SERVICE BULLETIN

ENGINE - LP TURBINE - INTRODUCE A NEW NO.5 BEARING FACE SEAL WITH A DECREASED THICKNESS - CATEGORY CODE 6 - MOD.ENG-72-0162

V2500-ENG-72-0162

Location of the No. 5 Bearing Face Seal
Fig.1

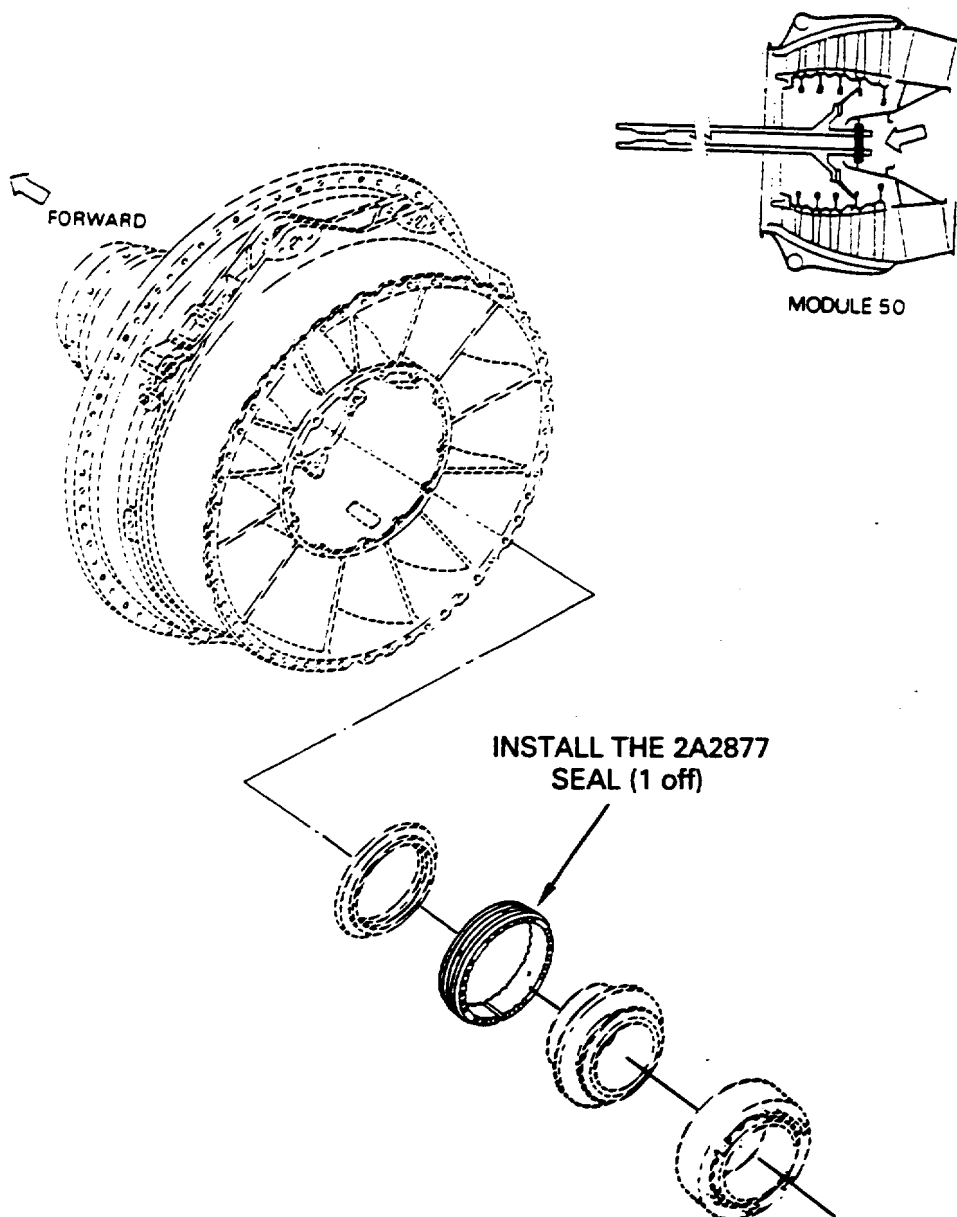
To replace the No. 5 Bearing Rear Seal with one that has a decreased radial thickness and improve the seal function.

- (1) This change provides a new No. 5 Bearing Face Seal, which has a decreased radial thickness.

- (a) Do an inspection of the No. 5 Bearing Face Seal to make sure that the radial thickness is 0.234 to 0.238in. (5,944 to 6,045 mm).

NOTE: The obsolete No. 5 Bearing Face Seals have a radial thickness of 0.338 to 0.346in. (8,585 to 8,788 mm). Do not use these seals.

- (c) Install the No. 5 Bearing Carbon Seal Assembly by the instructions given in Reference (4), Chapter/Section 72-50-00, Assembly-02. See Figure 1.

- (b) Install the No. 5 Bearing Carbon Seal Assembly by the instructions given in Reference (4), Chapter/Section 72-50-00, Assembly-02. See Figure 1.

- (b) Install the No. 5 Bearing Carbon Seal by Figure 1 and as follows:

- 2 Soak the carbon seal in hot CoMat 10-077 Approved Engine Oil for 10 minutes.
- 3 Install the front seal plate with the flat surface forward.
- 4 Install the carbon seal. Use light pressure and a push forward.
- 5 Install the rear seal plate. Make sure the groove points to the rear.
